Access Compliance Report

Public Rights-of-Way

Intersection ID: N/A	Main Street: GRAHAM_ST	Cross Street: N/A	Location: NW
ADA ID: 59AF16FB3227	Ramp Type: Directional1	Initial Pass/Fail: Fail	Overall Compliance: No
Severity Score: 1.25			
Codes/Mitigation Info/Possible Solution		Field Measurements/Component Compliance

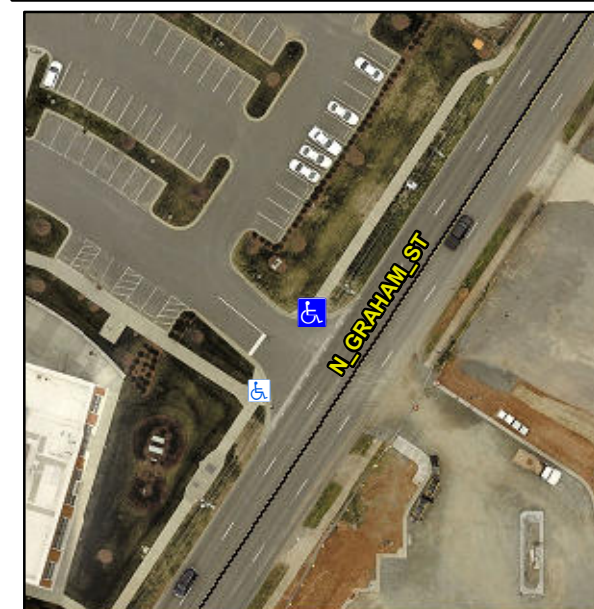
Remove & Replace Entire Ramp.

R304.5.3
